SERVING SENIORS BID ADDENDUM -B

SERVING SENIORS BID ADDENDUM -A

SERVING SENIORS FACILITIES IMPROVEMENTS – ROOFING AND FLOORING

SERVING SENIORS
ROOFING RECOAT AND FLOORING PROJECT
LIST OF CONTRACT DOCUMENTS: REVISED ADDENDUM A

MEZZANINE FLOOR FRAMING PLAN

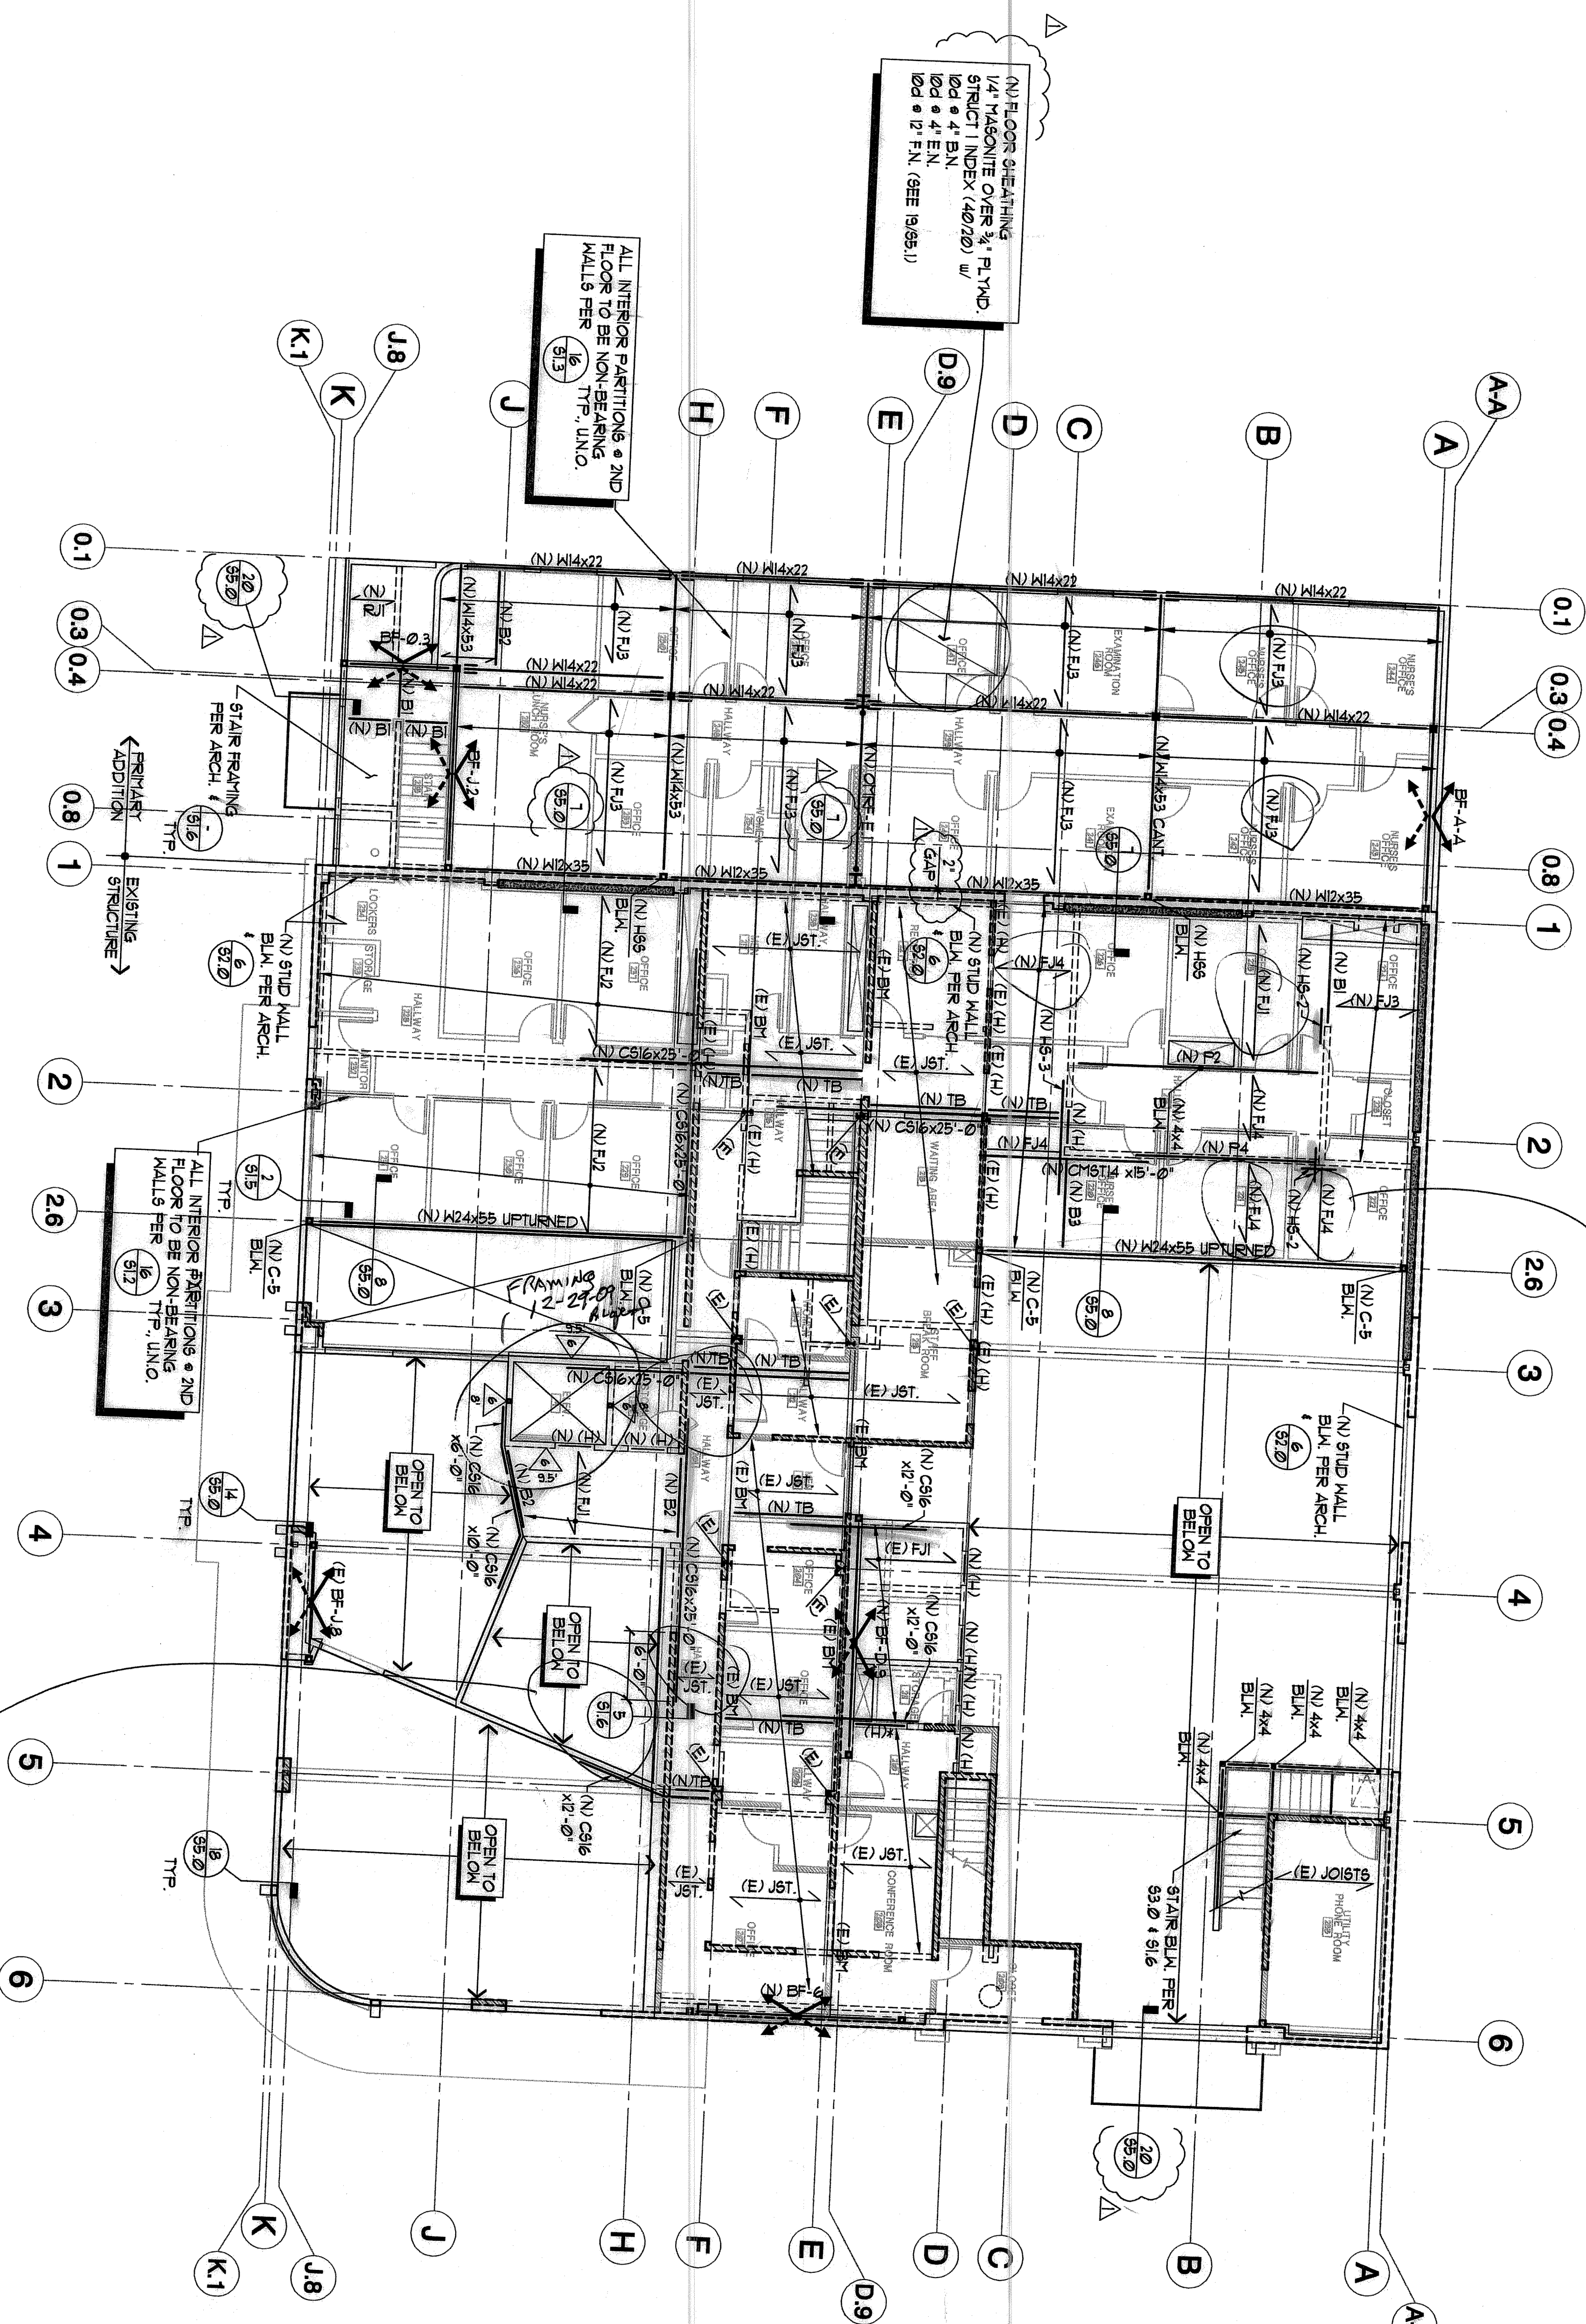
ROUGH FRAMING IS APPROVED EXCEPT THE FOLLOWING: GROUNDLINE 1-6 AND A-K *CORRECTIONS

1 SOUTH EAST STAIRWAY

*2 MEZZANINE 2ND FLOOR STRUCTURAL STEEL BEAMS TO LOW IN HALLWAYS, CITY PLANNING DEPT. APPROVED

DO NOT BEAR ON EXISTING JOIST

HEAD ROOM CLEARANCE, PER PREVIOUS REQUEST.

FIX REQUIRED APPROVED
